**AIP SUPPLEMENT
(SUP)****H45/22****Effective: 202205050100 UTC**AERONAUTICAL INFORMATION SERVICE,
AIRSERVICES AUSTRALIA, GPO BOX 367,
CANBERRA ACT 2601For **DISTRIBUTION** queries, contact:
Email: aim_editorial@airservicesaustralia.comFor **CONTENT** queries regarding this SUP, contact:
Email: smerlo@hobartairport.com.au**HOBART AIRPORT (YMHB) FREIGHT APRON
PARKING BAY RE-NUMBER****1. INTRODUCTION**

- 1.1 This SUP cancels and replaces SUP H23/22 with changes made to paras 2.5.1 and 2.5.2.
- 1.2 This SUP outlines the AIP publication changes as a result of Hobart Airport Freight Apron line marking works. It intends to provide notification to pilots of significant changes to parking position designators, alignment and associated lead-in lead-out line markings on the Hobart Airport freight apron.

1. Scope of works

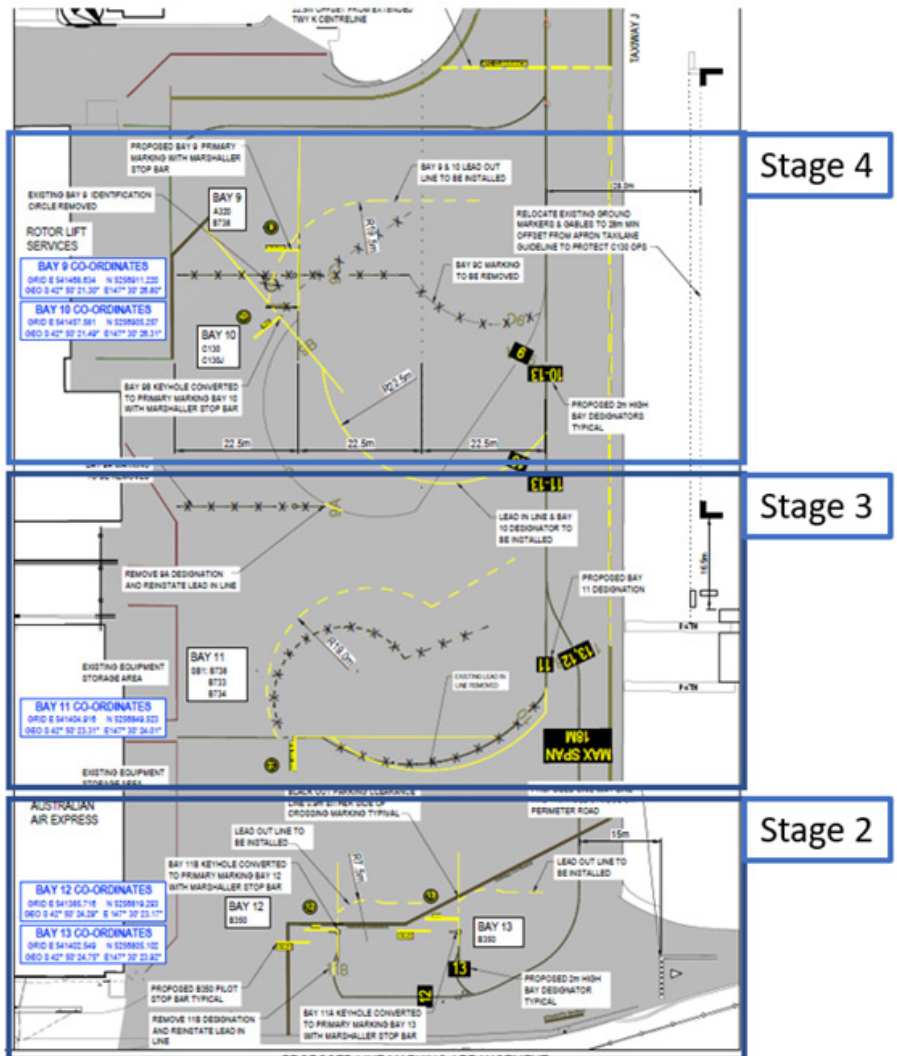
Current Bay Number	Re-designated Bay Number
9	No change
9A	Removed
9B	10
9C	Removed
10	11
11B	12
11A	13

2. Works staging

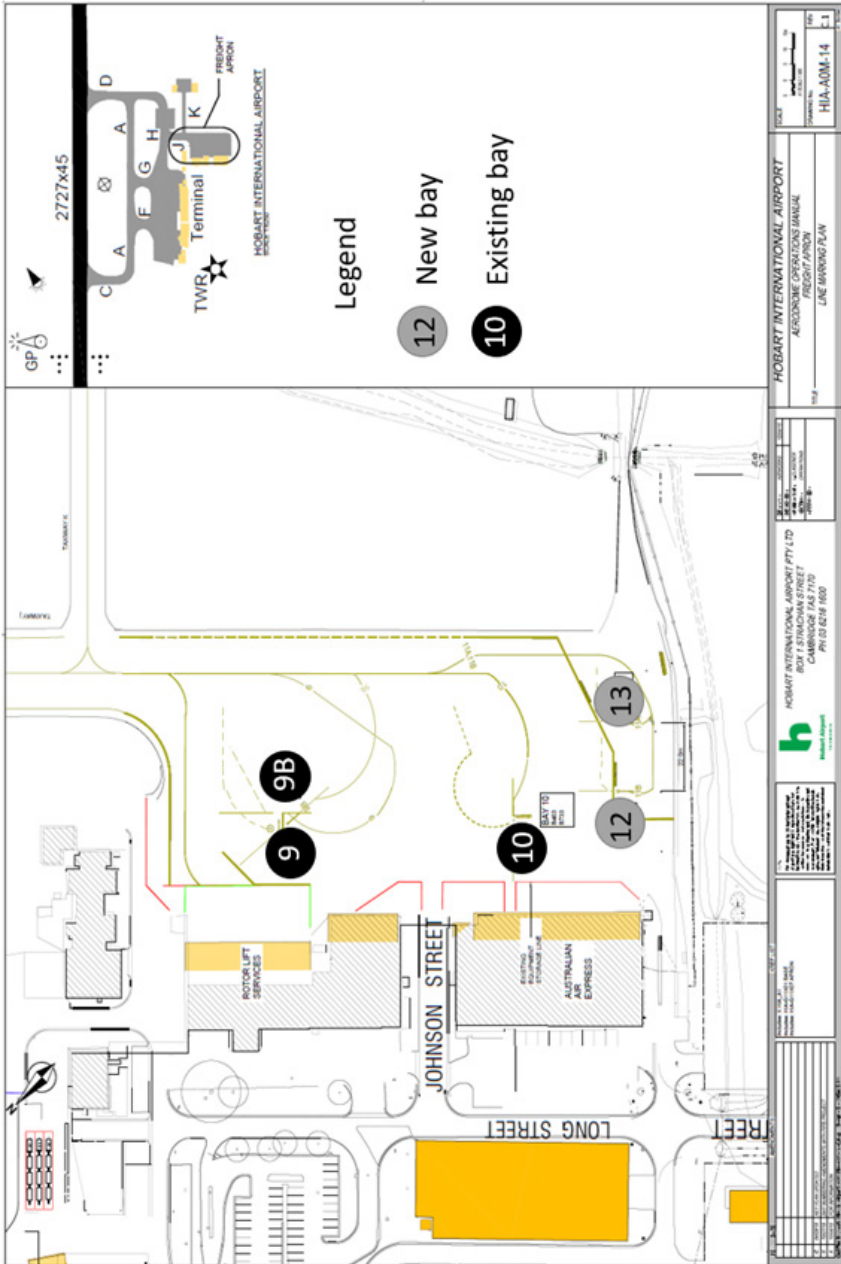
- 2.2.1 Between 202205012200 and 202205021000 UTC will only consist of surveying new line markings associated with the changes to the Bays. During stage 1 there will be no changes to Bay positions or markings.

- 2.3.1 Between 202205022200 and 202205031000 UTC existing Bays 11A and 11B will be removed and new Bays 12 and 13 installed. Existing bays 9, 9B and 10 available.
- 2.3.2 Between 202205031001 and 202205032159 UTC new Bays 12 and 13 and existing bays 9, 9B and 10 available. See Appendix 3.

- 2.4.1 Between 202205032200 and 202205041000 UTC existing Bay 10 will be renumbered Bay 11. New Bays 12 and 13 not available. Existing Bays 9 and 9B will available.
- 2.4.2 Between 202205041001 and 202205042159 UTC new Bays 11, 12 and 13 and existing bays 9, 9B available. See Appendix 4.

- 2.5.1 Between 202205082200 UTC and 202205091000 UTC existing Bay 9B will be renumbered Bay 10 and existing Bay 9 moved. New Bays 12 and 13 available. Existing Bays 9, 9B and new bay 11 will not available.
- 2.5.2 From 202205091001 UTC new Bays 9, 10, 11, 12 and 13 available. See Appendix 5.
